Access Compliance Report

Public Rights-of-Way

(Curb Ramps)

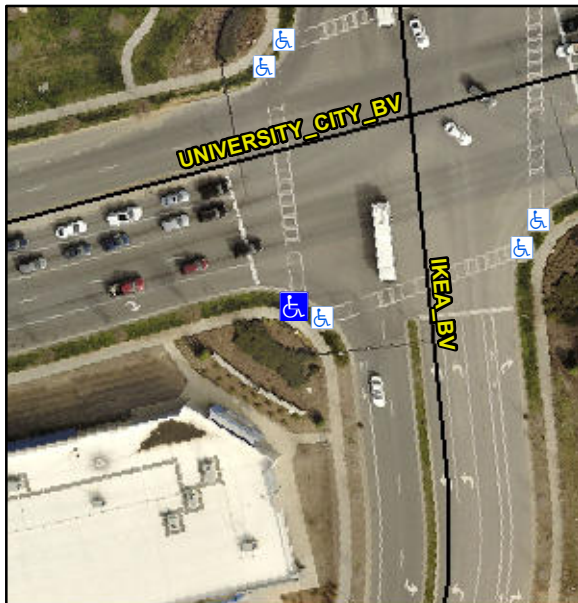
Intersection ID: 51369	Main Street: UNIVERSITY_CITY_BV	Cross Street: IKEA_BV	Location: SW
ADA ID: C459237A1102	Ramp Type: Perp	Initial Pass/Fail: Fail	Overall Compliance: No
Codes/Mitigation Info/Possible Solution		Field Measurements/Component Compliance	
Severity Score: 10

Not Found, R304.5.1, R304.5.3

Compliance	Description	Data	Compliance	Description	Data
N/A	Ramp Length (in)	96.0	Yes	Ramp Slope (%)	7.7
No	Ramp Width (in)	47.0	No	Ramp XSlope (%)	2.1
N/A	Flare Type LT	N/A	N/A	Flare Type RT	N/A
N/A	Flare Slope LT (%)	N/A	N/A	Flare Slope RT (%)	N/A
N/A	Flare Traversable LT?	N/A	N/A	Flare Traversable RT?	N/A
N/A	Landing Length (in)	N/A	N/A	DWS Provided?	N/A
N/A	Landing Width (in)	N/A	N/A	DWS Contrast?	N/A
N/A	Landing Slope (%)	N/A	N/A	DWS Length (in)	N/A
N/A	Landing X Slope (%)	N/A	N/A	DWS Full Width?	N/A
N/A	Landing Curb? (Y/N)	N/A	N/A	DWS Offset (in)	N/A
N/A	Shared Landing?	N/A			
N/A	Gutter Ponding?	N/A	N/A	Gutter Slope (%)	N/A
N/A	Gutter Lip Ht (in)	0.5	N/A	Gutter X Slope (%)	N/A
N/A	Painted X Walk1?	Yes	N/A	Painted X Walk2?	N/A
	X Walk 1 Direction	To N		X Walk 2 Direction	N/A
N/A	X Walk 1 Width (in)	78.0	N/A	X Walk 2 Width (in)	N/A
	X Walk 1 Slope (%)	3.1		X Walk 2 Slope (%)	N/A
	X Walk 1 X Slope (%)	0.8		X Walk 2 X Slope (%)	N/A

Remove & Replace Entire Ramp.
